HYDROLOGY H15/D27 NO PLANS

Re: Drainage Line Tie-In

RE: DRAINAGE LINE TIE-IN (H15-D27) RECEIVED FEBRUARY 16, 1984

SITE DRAINAGE LINE
PLANT #1

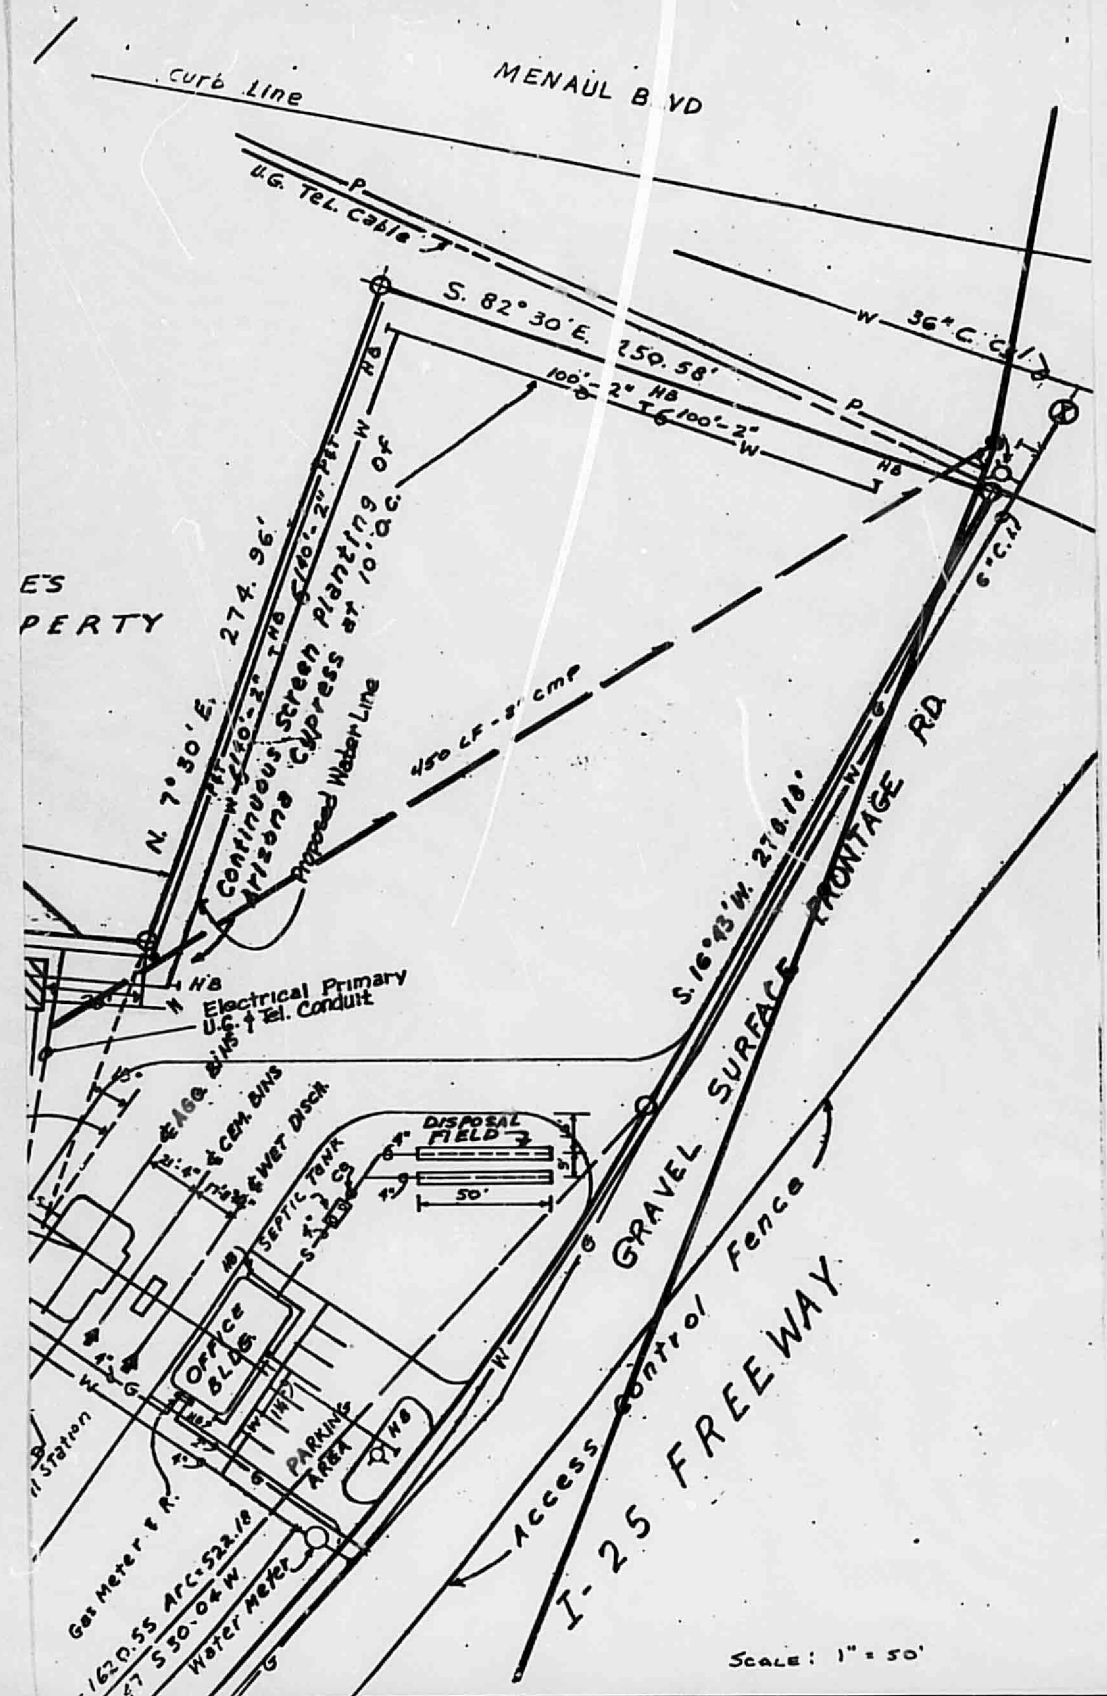
With respect to your submittal I would like to see what the pumping rate will be because the proposed discharge pipe is substantially larger than what exists. How will it impact the storm sewer system that is being tied into?

In response to your question concerning the pumping rate on the new 8" line, we will not be pumping the water at all. We intend to free fall the water instead of pumping from the existing sump. We'll block off the existing sump (the deep one inside the building) and let the water from the pre-sump feed directly into the new 8" line by gravity. (See enclosed photo of the pre-sump.)

TIE IN DETAIL

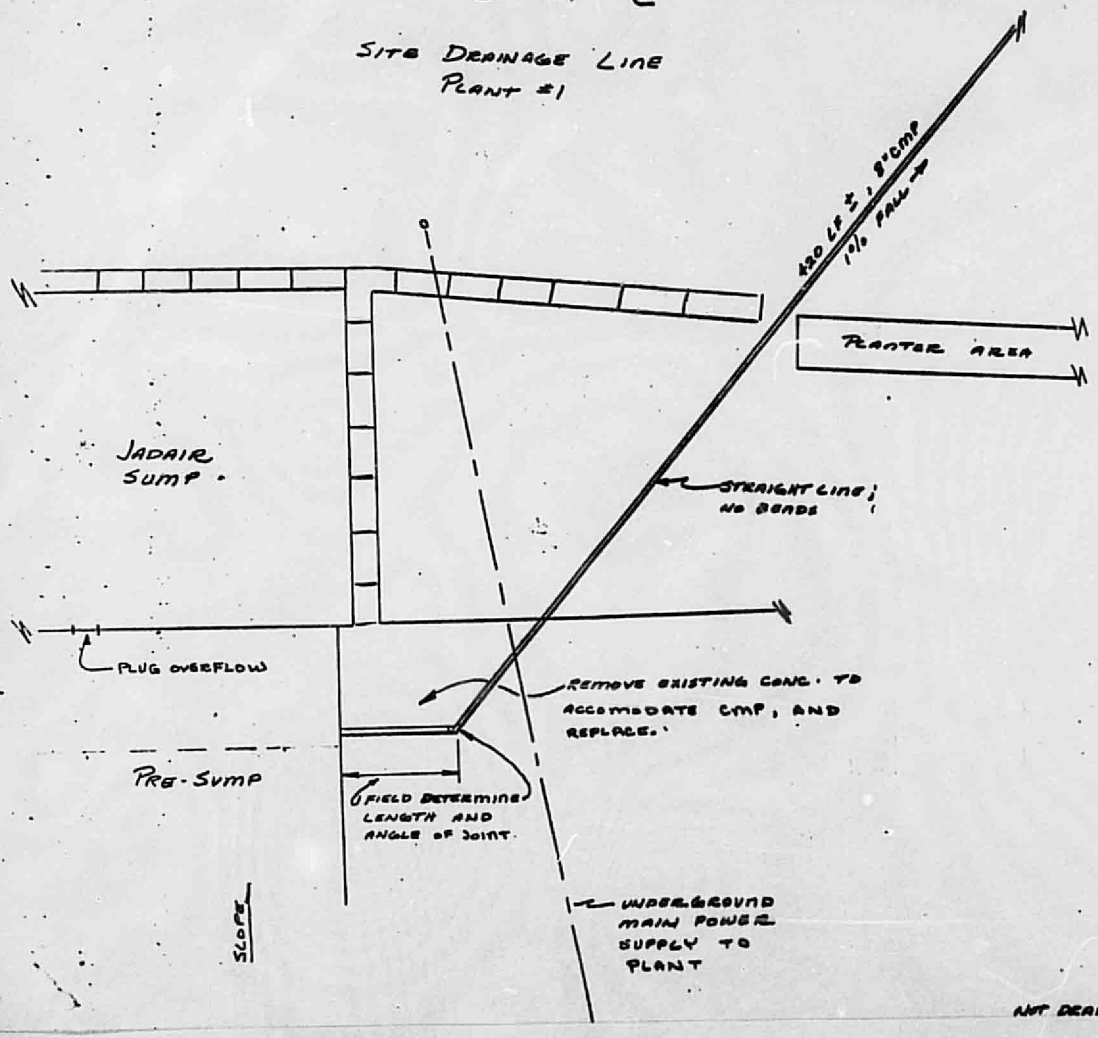
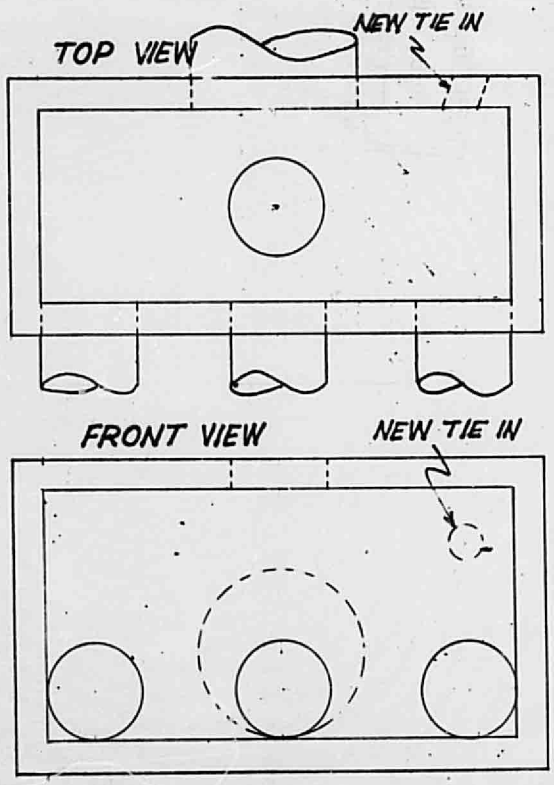
Also, you will need to submit these plans to Mr. Bob Keilich of the City Design section for his approval with respect to the details of the tie-in.
